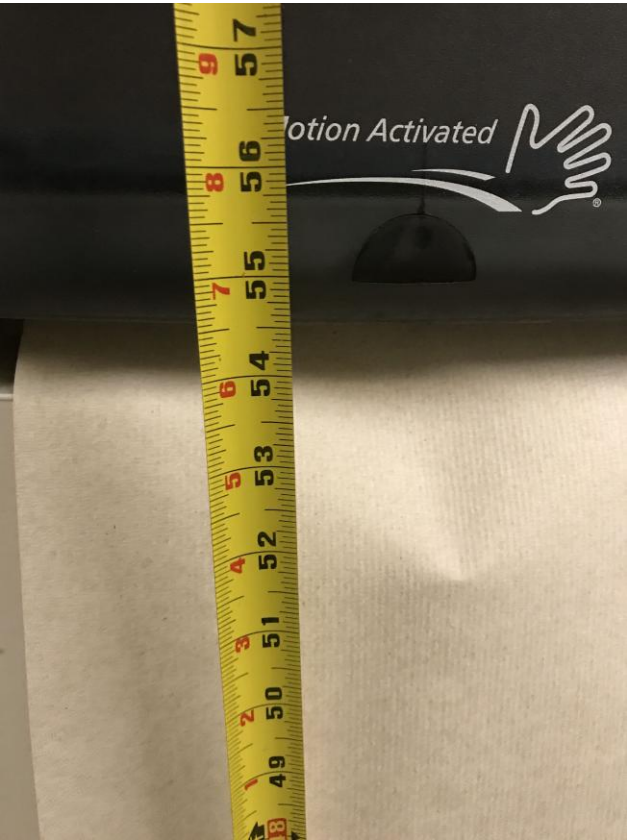
The pictogram field contains characters and/or Braille.

Pictogram 4 inches in height

Replace sign with compliant pictogram field of no less than 6 inches in height.

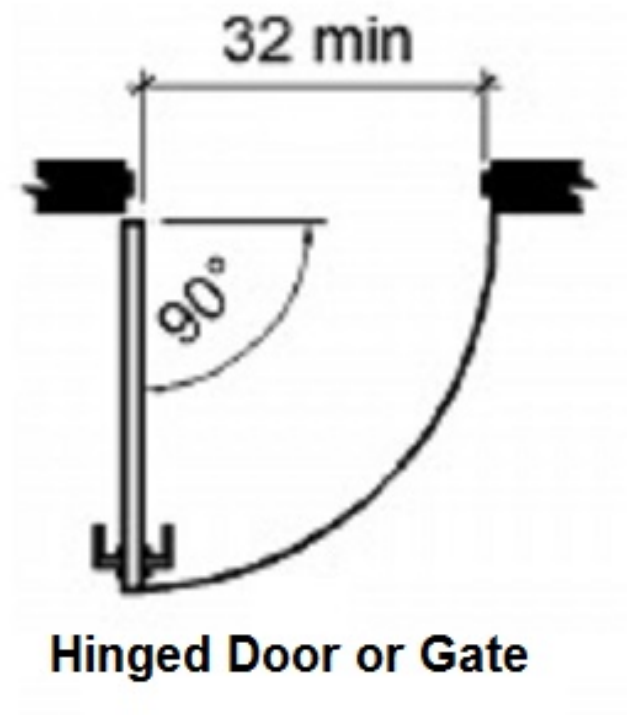
Neither leaves of the doorways provide at least 32 inches between the face of the door and the opposite stop.

Neither hallway entry doors provide the required 32 inches in width

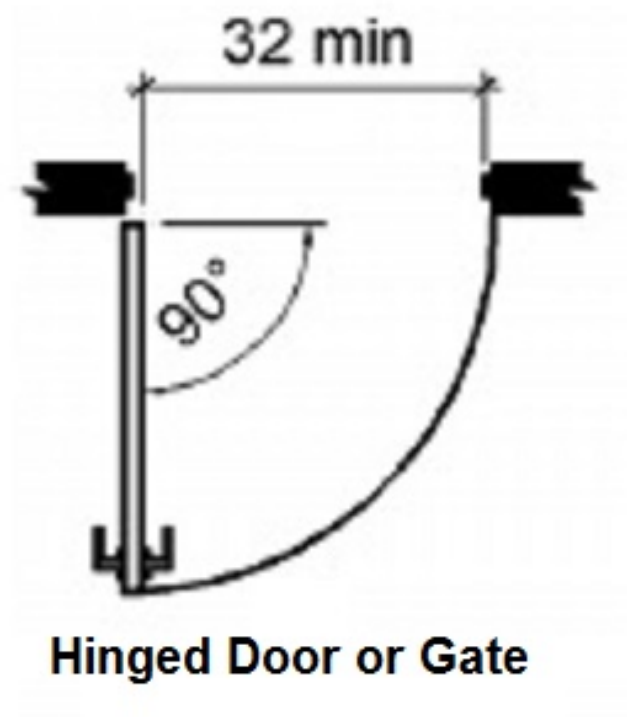
Neither leaves of the doorways provide at least 32 inches between the face of the door and the opposite stop.

Neither hallway entry doors provide the required 32 inches in width

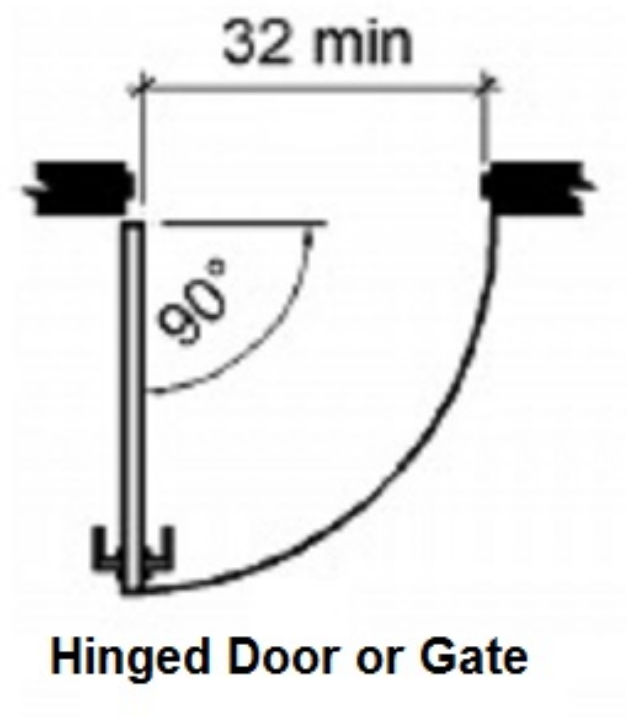
Neither leaves of the doorways provide at least 32 inches between the face of the door and the opposite stop.

Neither hallway entry doors provide the required 32 inches in width

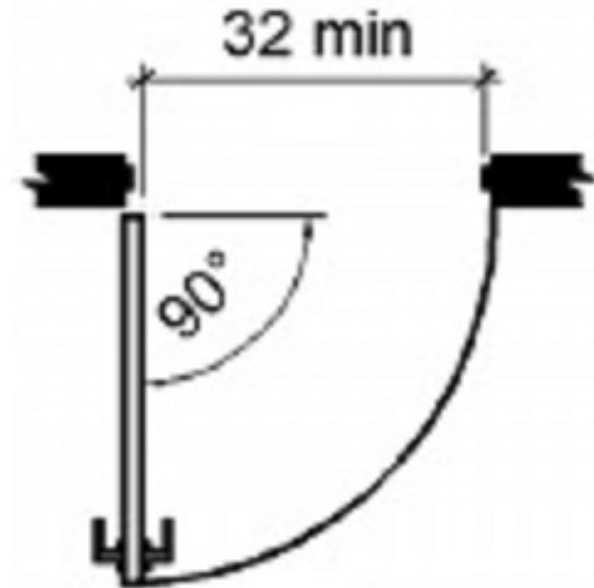
Neither leaves of the doorways provide at least 32 inches between the face of the door and the opposite stop.

Install/widen door frames to meet compliance of 32 inches minimum or keep both doors open to provide minimum required clearance.
